A meeting of the Bayside Local Planning Panel

Item No 6.1

Application No DA-2025/8

Property 55-61 Bonar Street, Arncliffe

Figure 9: Tree location plan, with hose highlighted in purple proposed to be removed

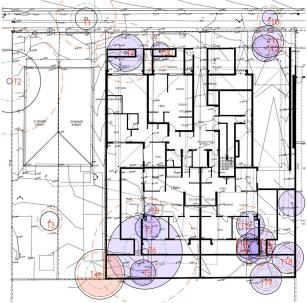
The recommendation from the DRP was that the large mature Moreton Bay Fig tree in the south-western corner of the site (T6 in Figure 9 above) was to be retained as it will provide positive amenity to the proposed communal open space area.

In light of the above, insufficient information has been provided to justify removal of the Moreton Bay Fig tree. Therefore, on balance, the proposal is not considered to be acceptable in regards to this SEPP. If approval was recommended, conditions including retention of Tree 16 and a 3:1 ratio relating to three trees to be planted for every one removed would have been imposed.

Figure 12 – Height plane diagram showing non-compliances with maximum building height (supplied by applicant)

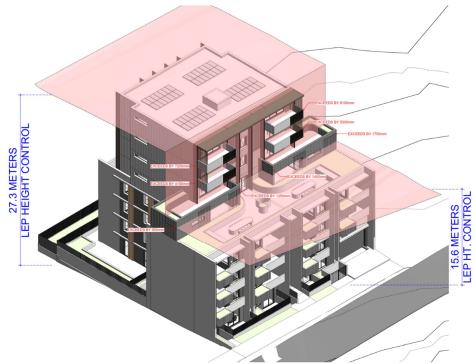
It is noted that the majority of the building is sited within the allowable transitional height envelope (i.e. within the 27.3m maximum Height of Building area).

The applicant's Section 4.6 request argues that compliance with the development standard is unreasonable or unnecessary in the circumstances of the case and that there are sufficient environmental planning grounds to support the non-compliant Height of Building.
